Appendix B
Comment Letters

Subject: Comments Regarding Tentative Order Reissuing the NPDES Permit (CA0037834) for Palo Alto Regional Water Quality Control Plant

City of Palo Alto
Palo Alto Regional Water Quality Control Plant

Comments Regarding Tentative Order for Reissuance of NPDES Permit

Table F-9. Monitoring Requirements Summary

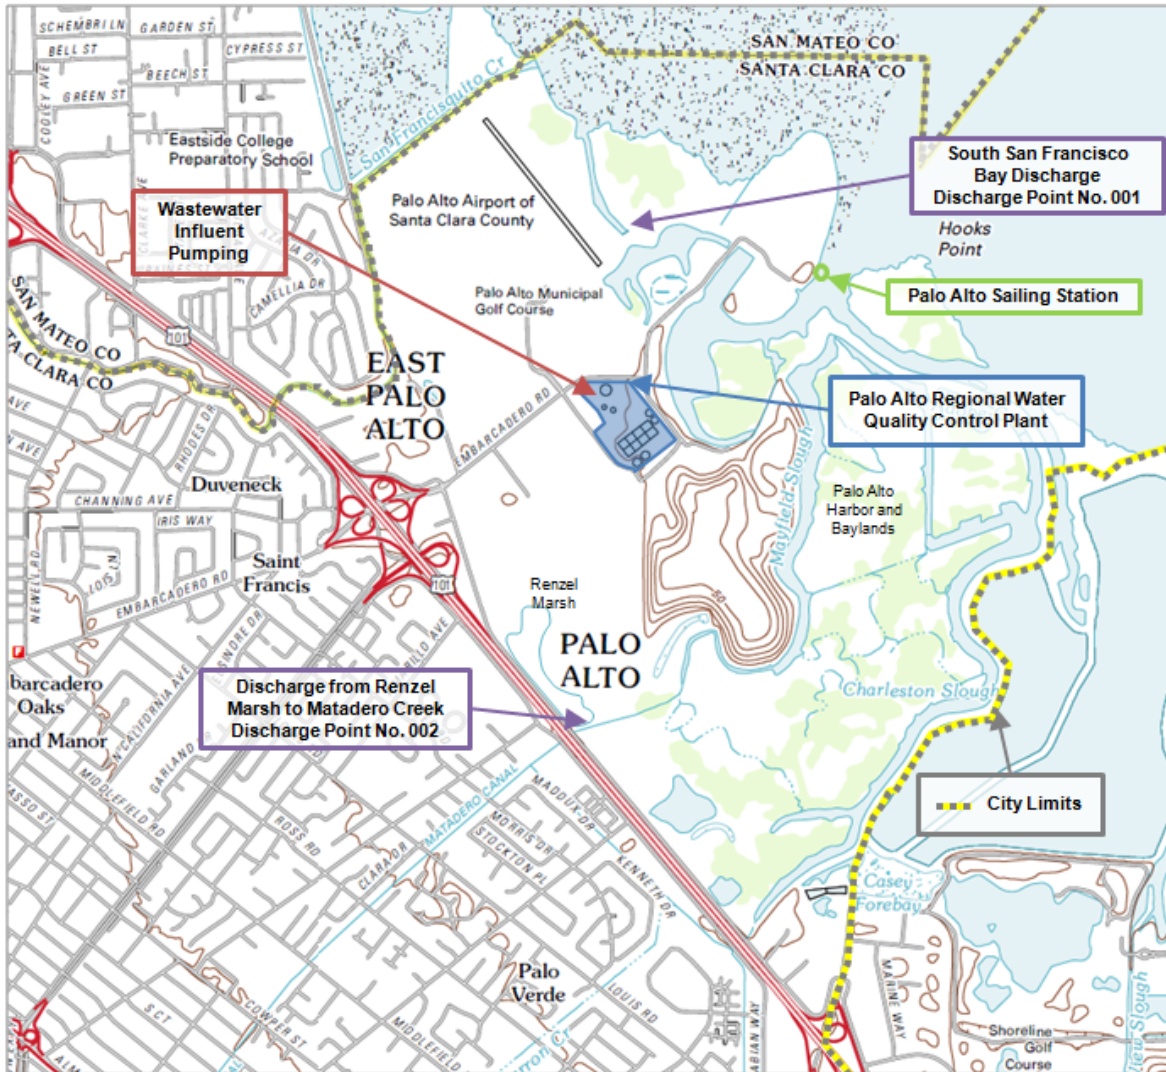
17. The City requests modifications to Table F-9 to reflect the requested monitoring changes in these comments as well as the removal of the paint filter test requirement which is not applicable.

The markups provided below reflect the requested changes in the comments above and consistency with the Monitoring and Reporting Program. In addition, the City requests the removal of the paint filter test monitoring requirement. The rationale presented for the paint filter test is provided in Attachment G Part III.B. 2. for ash that are sent to a municipal landfill. However, the City sends the incinerated ash to a hazardous waste landfill and monitors the biosolids in accordance with the requirements of that landfill and state-only regulations, and a paint filter test is not required for this activity.

Parameter	Influent INF-001	Effluent EFF-001	Effluent EFF-002	Receiving Water RSW-001	Receiving Water RSW-002	Incinerator Ash ASH-001
Flow Rate	Continuous/D	Continuous/D	Continuous/D	---	---	---
CBOD ₅	1/Week	1/Week	---	---	---	---
TSS ^[F.2]	1/Week	1/Week	---	---	---	---
CBOD ₅ and TSS percent removal	---	1/Month	---	---	---	---
pH	---	Continuous/D or 1/D	---	1/Quarter	1/Quarter	---
Oil and Grease	---	1/Quarter	---	---	---	---
Turbidity	---	1/Week	---	---	---	---
Fecal Coliform	---	1/Quarter ^{2/} Week	---	Support RMP	---	---
Enterococcus	---	2/Week	---	Support	---	---

Parameter	Influent INF-001	Effluent EFF-001	Effluent EFF-002	Receiving Water RSW-001	Receiving Water RSW-002	Incinerator Ash ASH-001
Bacteria		1/Quarter		RMP		
Total Ammonia Nitrogen	---	1/Month	---	1/Quarter	1/Quarter	---
Acute Toxicity	---	1/Quarter	---	Support RMP	---	---
Chronic Toxicity	---	1/Month 1/Quarter	---	Support RMP	---	---
Copper	---	1/Month	---	Support RMP	---	---
Nickel	---	1/Month	---	Support RMP	---	---
Cyanide	1/Month	1/Month	---	Support RMP	---	2/Year
Dioxin-TEQ	---	2/Year	---	Support RMP	---	---
Standard Observations	---	---	1/Month	1/Quarter	1/Quarter	---
Salinity	---	---	---	1/Quarter	1/Quarter	---
Hardness	---	---	---	1/Quarter	1/Quarter	---
Temperature	---	---	---	1/Quarter	1/Quarter	
Volatile Organic Compounds	2/Year	2/Year	---	---	---	2/Year
Base/Neutrals Acid Extractable Organic Compounds	2/Year	2/Year	---	---	---	2/Year
Metals and Non-Metallie Elements	1/Month	1/Month	---	---	---	2/Year

Metric tons/year	---	---	---	---	---	Attach. G §III.B.1
Paint filter test	---	---	---	---	---	Attach. G §III.B.2

Figure 1 Computed 24-hour fecal coliform dilution contours during August 2011.

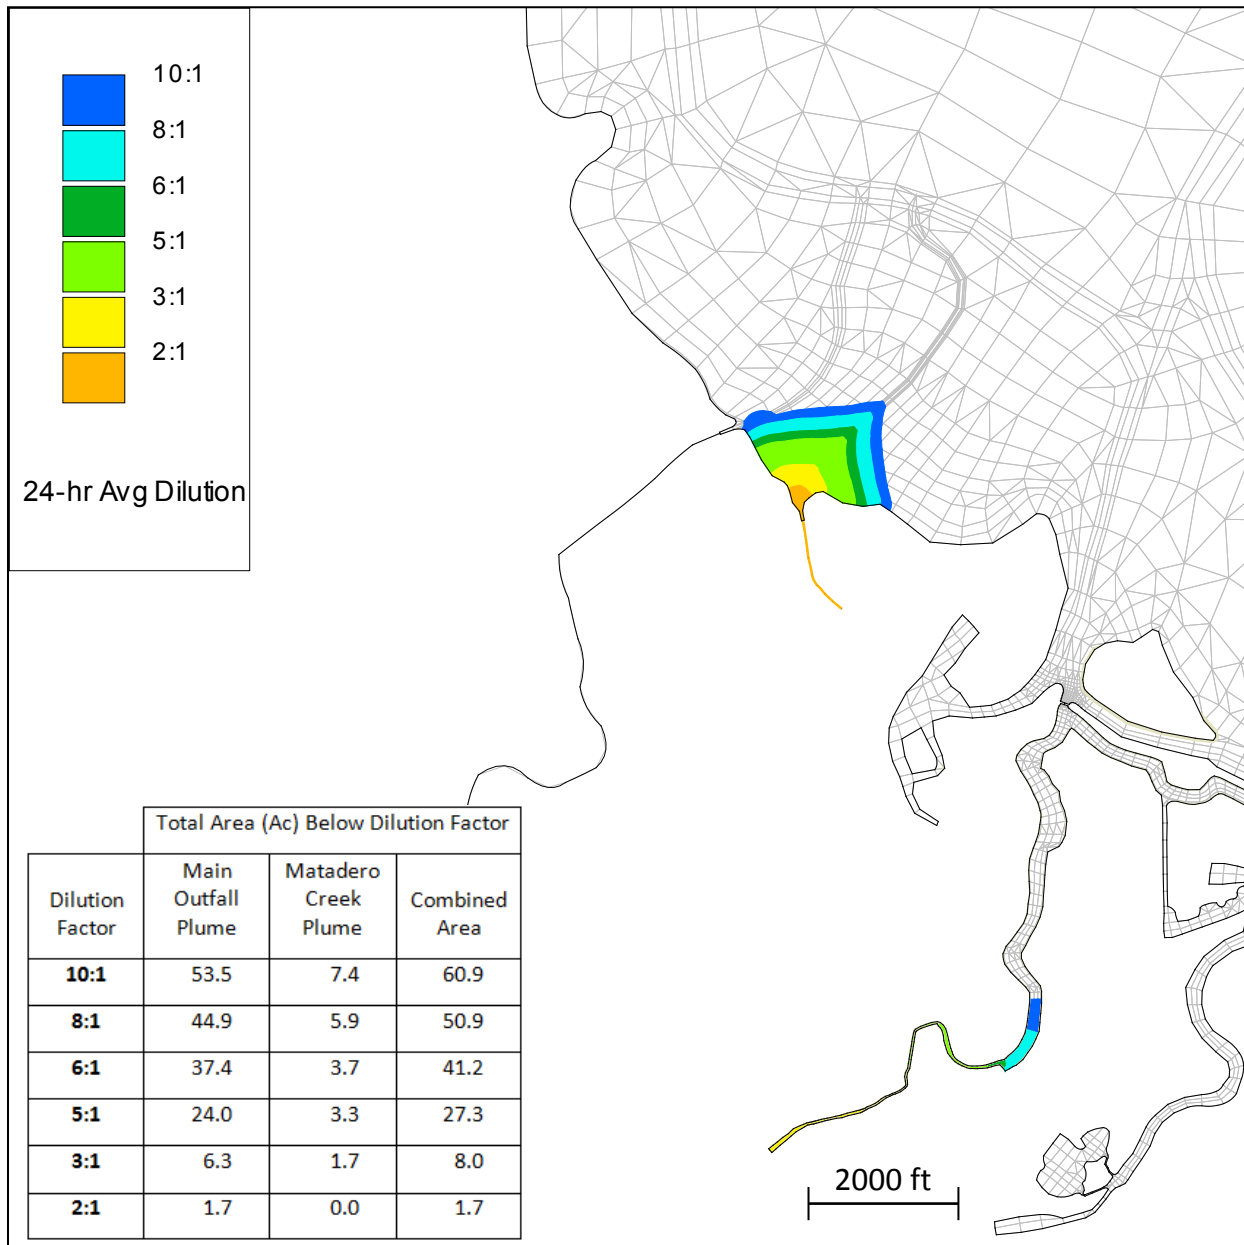
As noted above, the proposed dilution credit of 2:1 in the Tentative Order does not take into account the impact of natural bacterial die-off, which would be expected to reduce fecal coliform concentrations in wastewater by more than a factor of 1.5 in a 24-hour period, as demonstrated in the City's 2014 *Dilution Analysis of Palo Alto Regional Water Quality Control Plant's*

Discharge to South San Francisco Bay and Matadero Creek – Technical Memorandum Addendum (see attached). The mortality rate of 1.0 day⁻¹ used in the *Technical Memorandum Addendum* is a conservative estimate that does not consider the effects of temperature, light, or settling, which can further reduce fecal coliform concentrations. Accounting for both bacterial die-off and dilution by water from South San Francisco Bay, fecal coliform concentrations are expected to be reduced by at least a factor of seven within the boundary of the Palo Alto Baylands Nature Preserve and within 50 acres of the City's two outfalls. Therefore, a mixing zone for fecal coliform reflecting a dilution ratio of 7:1 will be protective of the shellfish beneficial use outside the boundaries of the Nature Preserve.
